Tavis House

Planning Response 01
- Camden Cycling Campaign

9th February 2022

Proposed Ground Floor Plan - Feb 2022

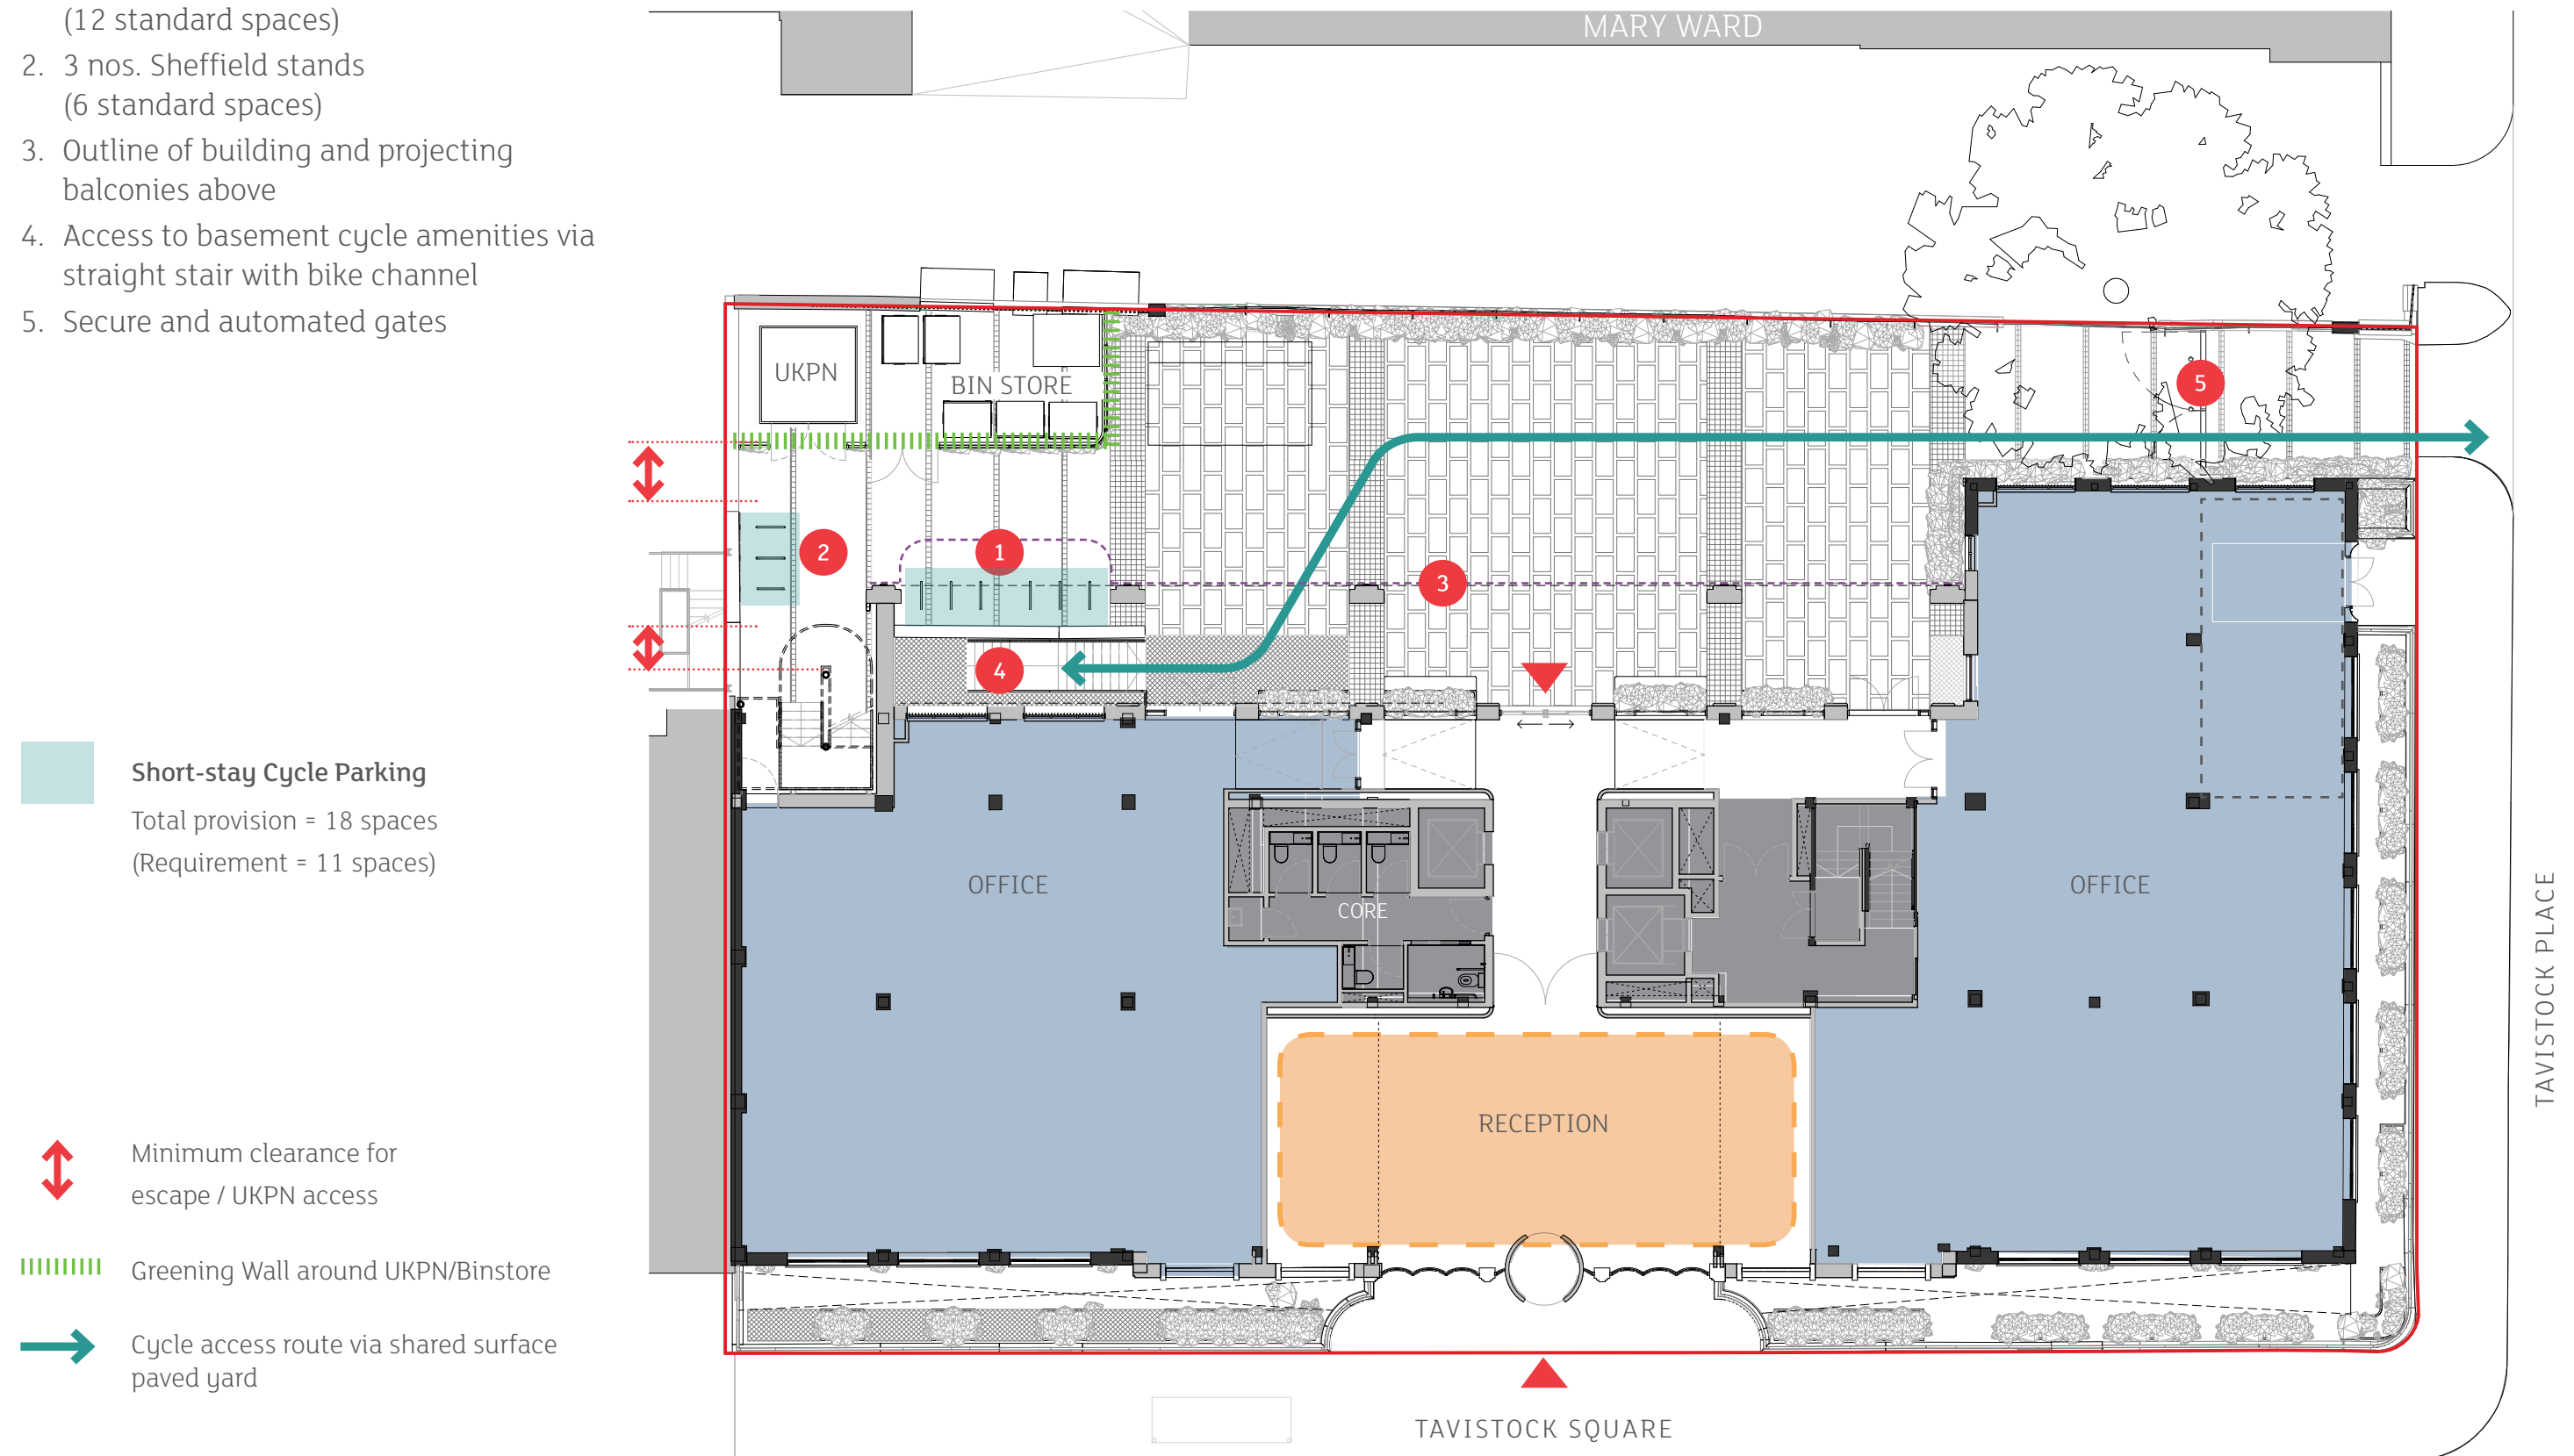
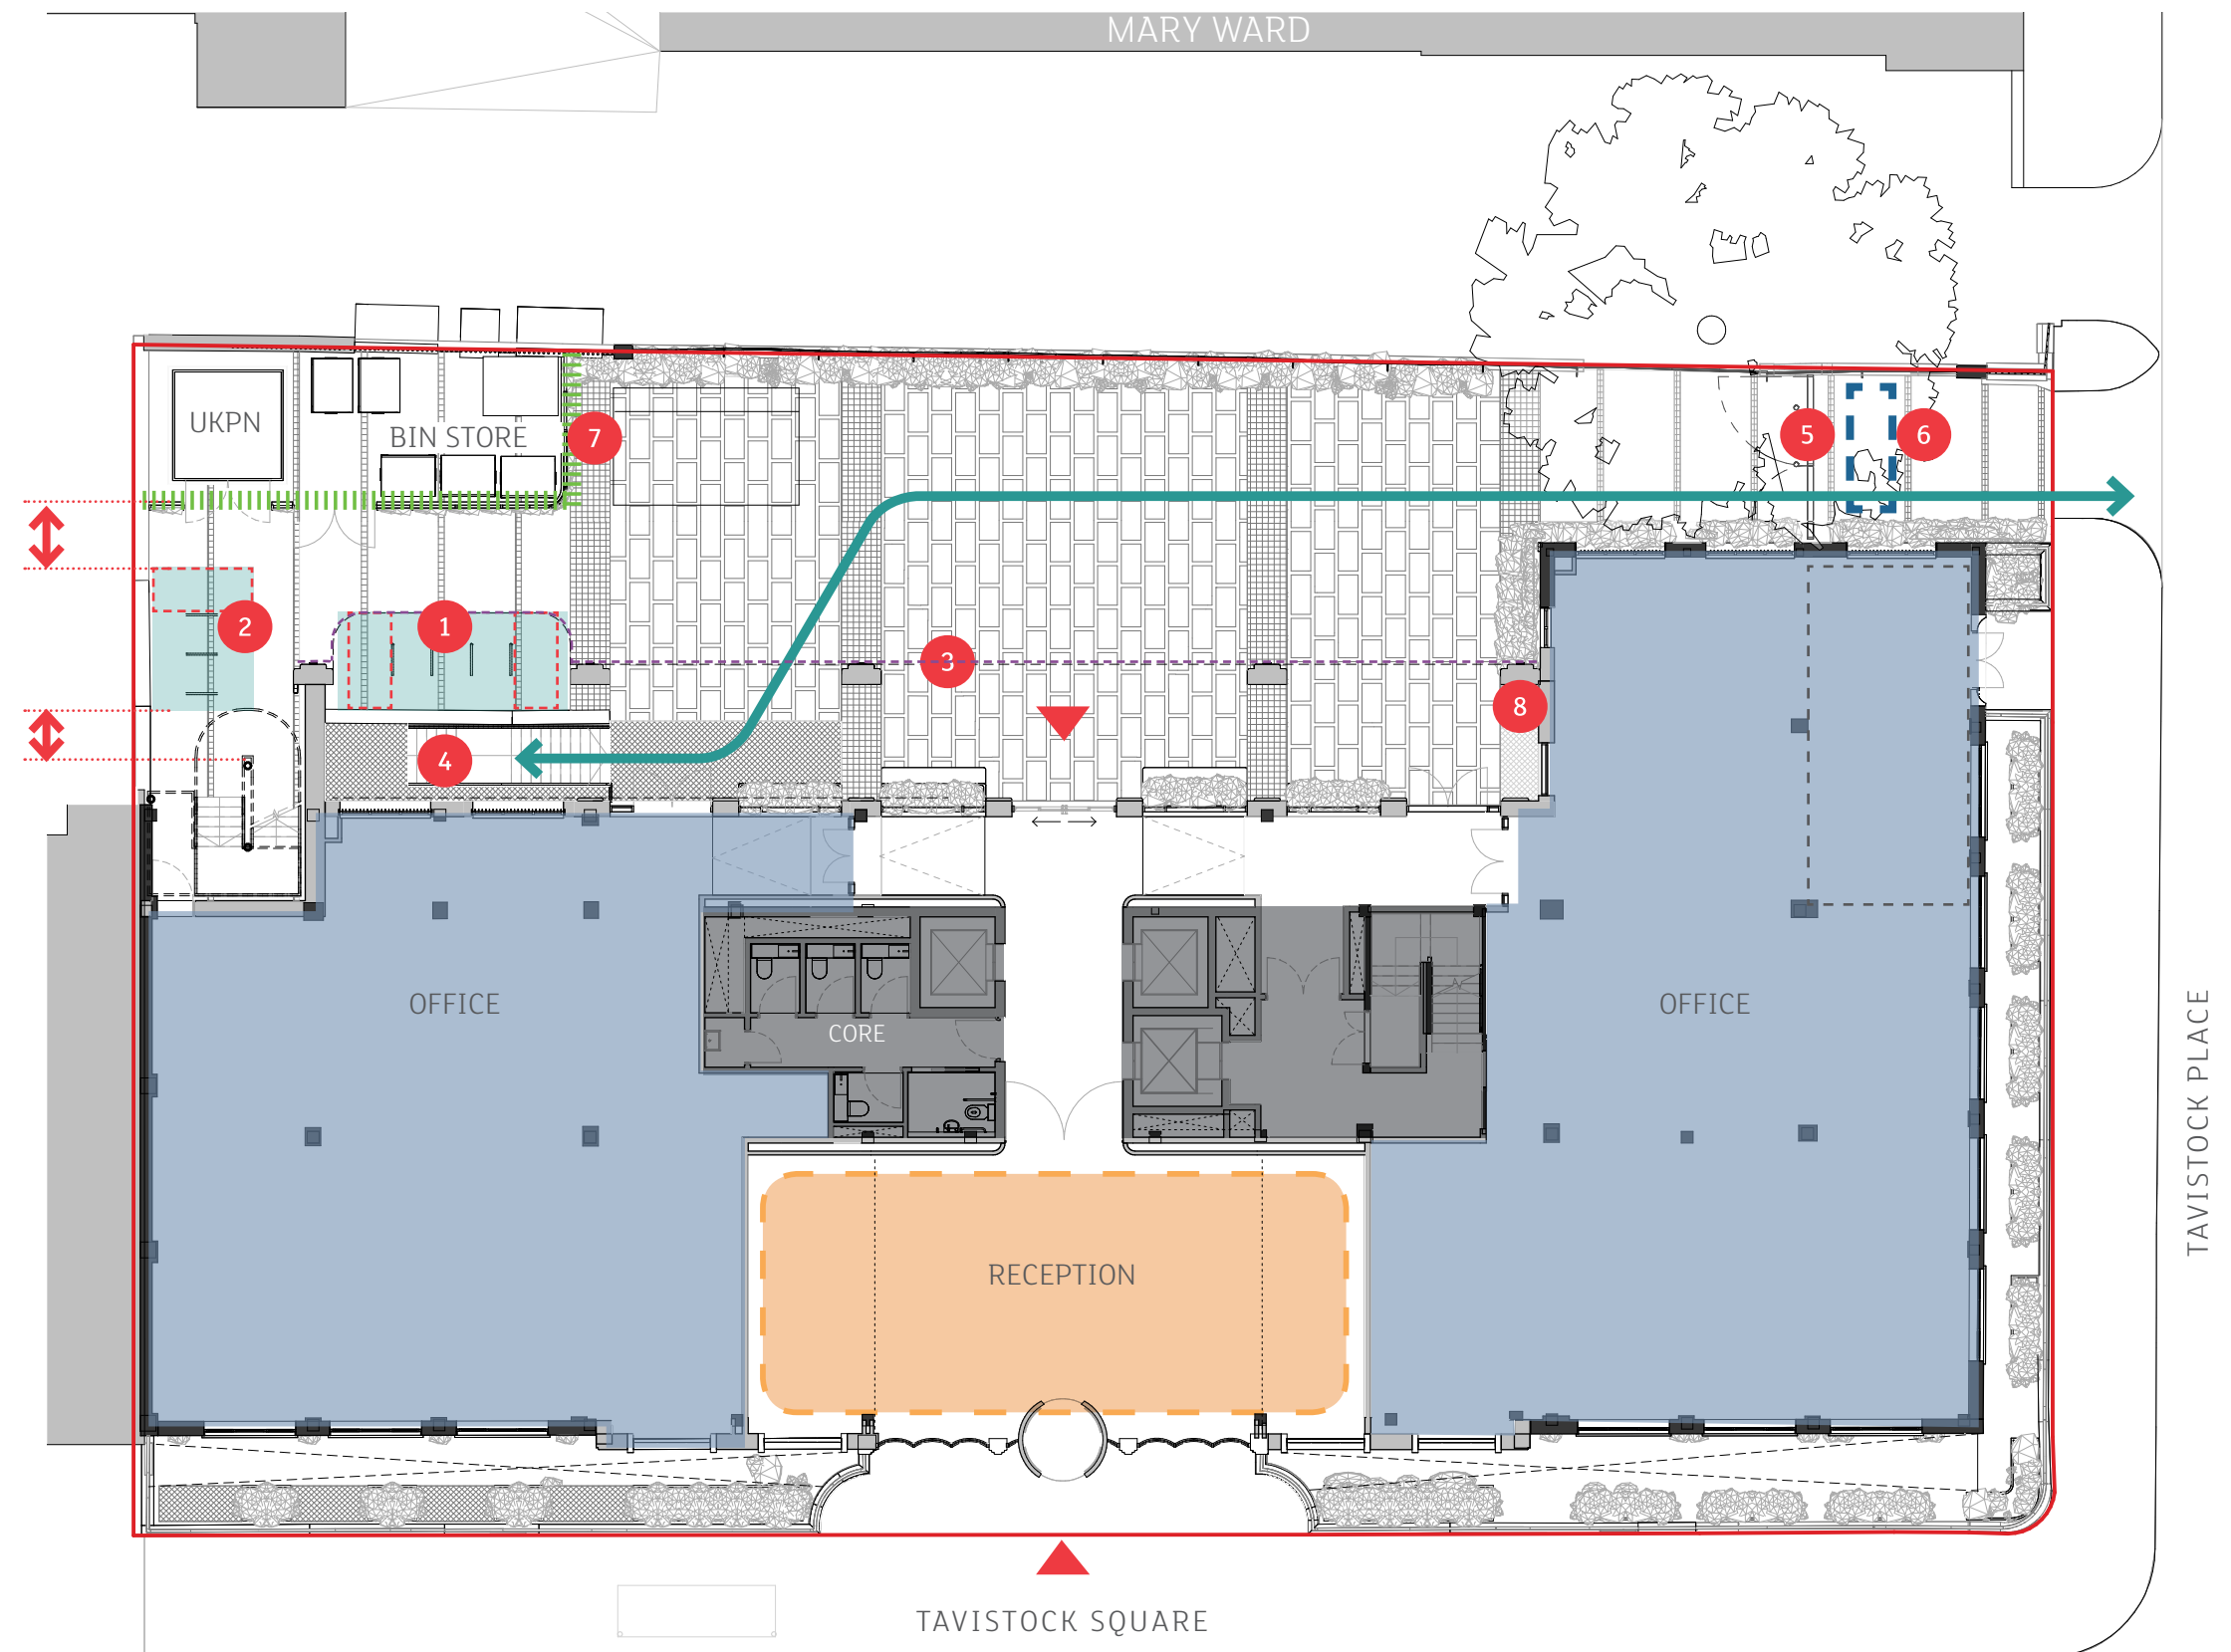
This document highlights the following updates to the Transport and Cycling provisions :

- 1 passive electric vehicle charging point (EVCP) to the disabled parking bay
- 1 active EVCP to the servicing bay
- An overprovision of 3 short stay cycle spaces on the ground floor, including 3 non-standard spaces
- 'Reduce Speed' or similar paved text located at entrance of shared surface rear yard.
- Omission of all vertical cycle parking in the basement in lieu of two-tier racks and sheffield stands.

- Dashed building outline includes projecting balconies above
- Basement cycle amenities (long stays only) accessed via straight flight stairs with bike channel
- Secure gates on automated push button provide security to the rear yard. This is in addition to proposed CCTV surveillance.
- Location of short stay spaces on the ground floor located in the furthest / most secure point from the main roads.

1. Covered 4 nos. Sheffield stands (6 standard, 2 non-standard spaces)
2. 3 nos. Sheffield stands (5 standard, 1 non-standard spaces)
3. Outline of building and projecting balconies above
4. Access to basement cycle amenities via straight stair with bike channel
5. Secure and automated gates
6. 'Reduce Speed' or similar text integrated into paving
7. 1 passive EVCP provision
8. 1 active EVCP wall-mounted

-  **Short-stay Cycle Parking**
Total provision = 14 spaces
(Requirement = 11 spaces)
-  Non-standard cycle space
-  'Reduce Speed' or similar paved text
-  Minimum clearance for escape / UKPN access
-  Greening Wall around UKPN/Binstore
-  Cycle access route via shared surface paved yard

Proposed Basement Plan - Feb 2022

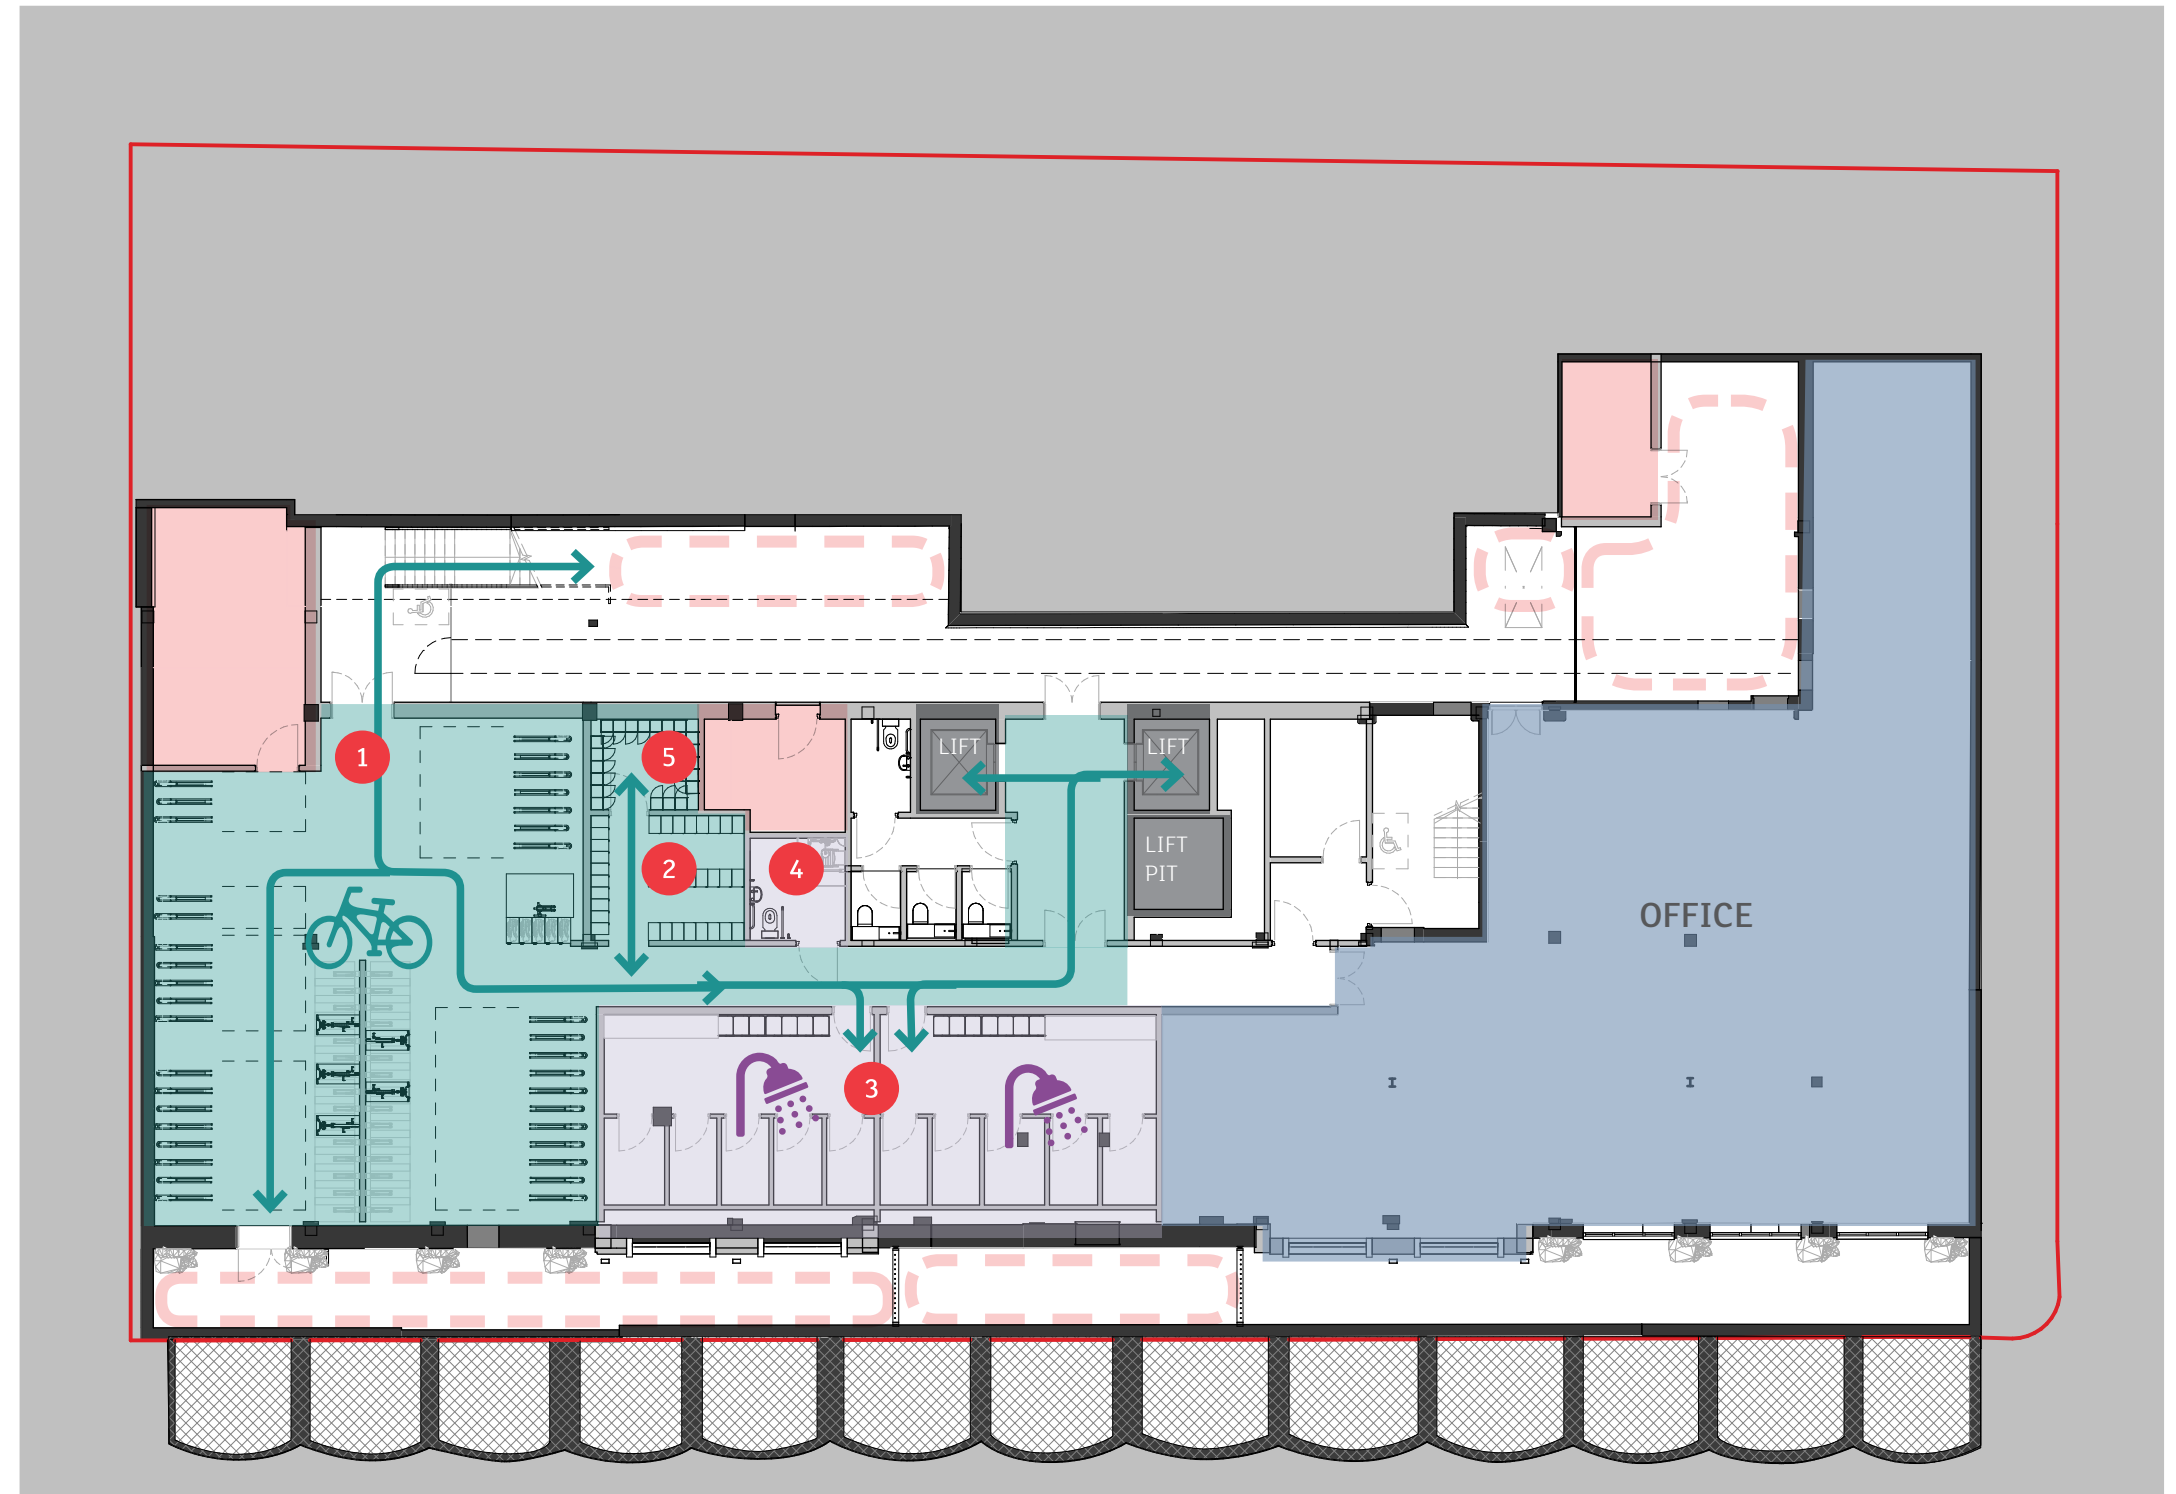
1. TOTAL 115 long-stay cycle spaces

- 94 Two-tier stacked
- 6 Sheffield spaces
- 15 Foldable cycles
